Re: Take 5 Oil Change 2151 Gibson Blvd. SE Traffic Circulation Layout Engineer's Stamp 08-28-23 (M15-D021E)

TAKE 5 OIL CHANGE

CIVIL CONSTRUCTION DRAWINGS

SITE PLAN

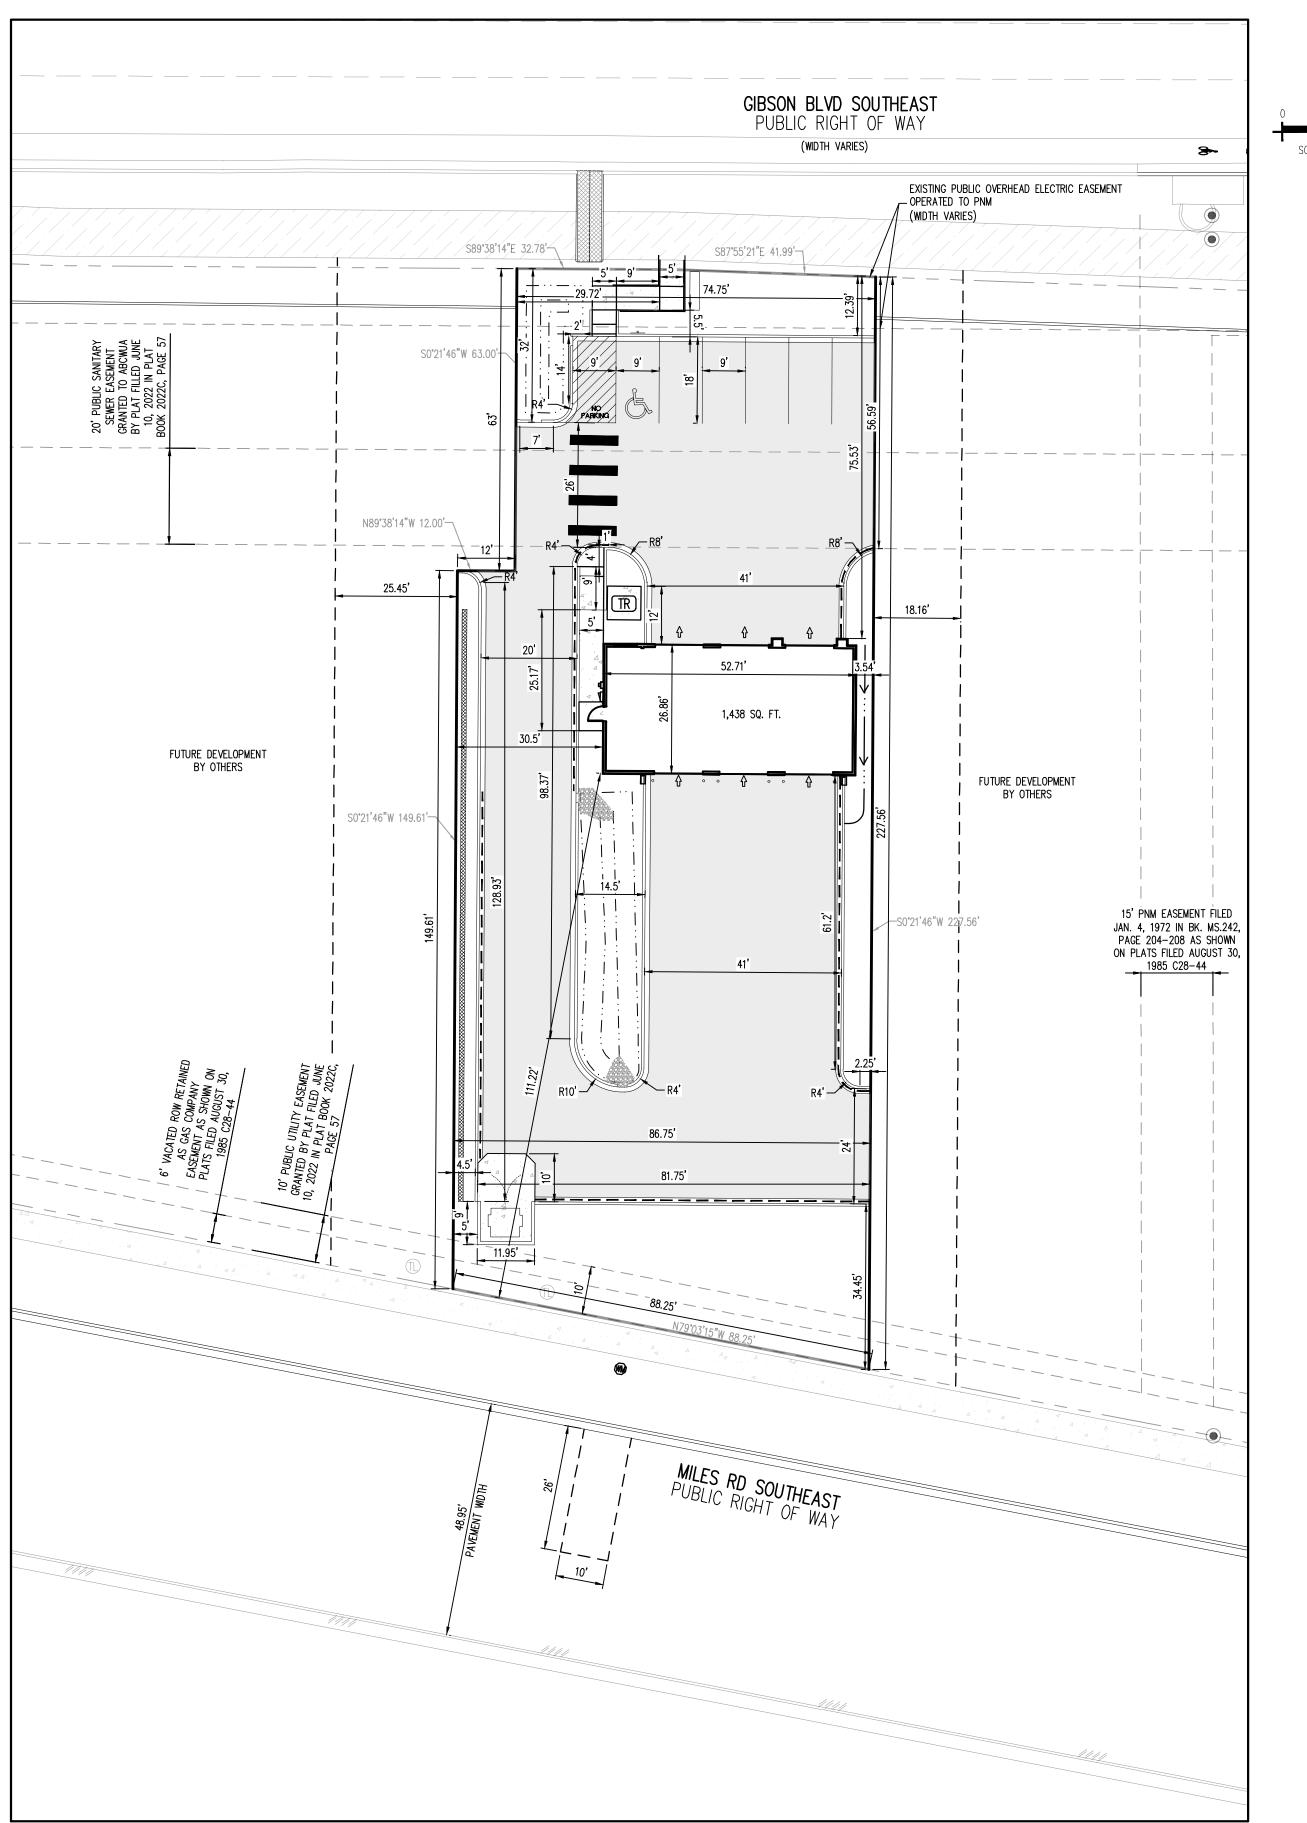
- 1. Identify all existing access easements and rights of way width dimensions.
- PO Box 1293
- 2. Identify the right of way width, medians, curb cuts, and street widths on Gibson Blvd. and Miles Rd.
- 3. Per the DPM, the minimum two-way traffic drive aisle width should be 22 ft.
- Albuquerque
- 4. Please provide shared access and shared drive aisle agreement.
- 5. Sheet C1.4 shows an ADA handrails details. Please clarify the location of the proposed handrails.
- NM 87103
- 6. The ADA accessible parking sign must have the required language per 66-7-352.4C NMSA 1978 "Violators Are Subject to a Fine and/or Towing." Please call out detail and location of signs.

- 7. Per the IDO, a 6 ft. wide ADA accessible pedestrian pathway is required from the public sidewalk to the building entrances. Please clearly show this pathway and provide details.

- 8. Per DPM, a 6 ft. wide ADA accessible pedestrian pathway is required from the ADA parking stall access aisles to the building entrances. Please clearly show this pathway and provide details.

- 9. ADA accessible pedestrian pathway should not be placed behind parking space or adjacent to a vehicular way. Vehicle and pedestrian/wheel chair conflicts should be avoided as much as possible.

- 10. Refuse vehicle maneuvering shall be contained on-site. The refuse vehicle shall not back into the public right of way.; provide a copy of refuse approval.

- 11. Please provide a copy of Fire Marshal approval.
- 12. All one-way drives shall have "One Way" and "Do Not Enter" signage and pavement markings. Please show detail and location of posted signs and striping.

- 13. Please specify the City Standard Drawing Number when applicable.
